UNITED STATES PATENT AND TRADEMARK OFFICE

APPLICATION NO.	FILING DATE	FIRST NAMED INVENTOR	ATTORNEY DOCKET NO.	CONFIRMATION NO.
10/560,415	12/13/2005	German Jauregui	98884.000010	5464

Office Action Summary	Application No. 10/560,415	Applicant(s) JAUREGUI, GERMAN	
	Examiner ERNESTO GARCIA	Art Unit 3679

DETAILED ACTION

Fig. 11

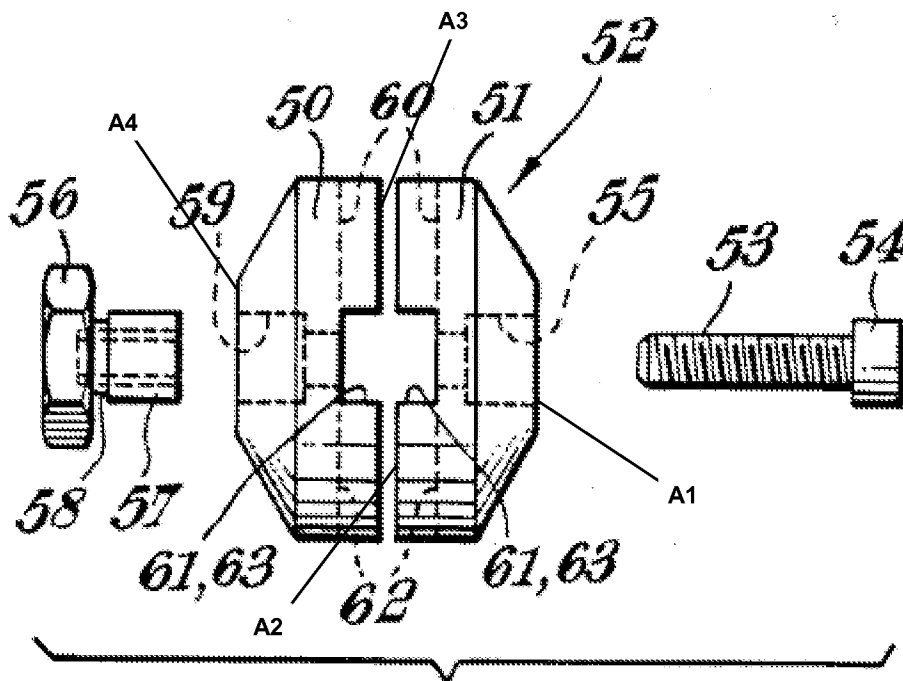
Regarding claim 1, as best understood, Pitt discloses, in Figure 11, a structural connection system comprising at least two of the following members: a closing support member **51**, an off-centered support member, and a vertical support member **50**. The closing support member **51** comprises a piece having any geometry having a top surface **A1**, a bottom surface **A2**, and a diametric channel housing **61**, **63** which extends under the top surface **A1**. The piece incorporates an attachment means **55**. The vertical support member **50** comprises a piece having any geometry having a top surface **A3**, a bottom surface **A4**, and a diametric channel housing **61**, **63** which extends under the top surface **A3**. The vertical support member **50** incorporates an attachment means **59**. The bottom surface **A4** of the vertical support member **50** comprises a male or pin element **57** extending axially.

Regarding claim 2, the closing support member **51** and the vertical support member **50** have a cylindrical shape.
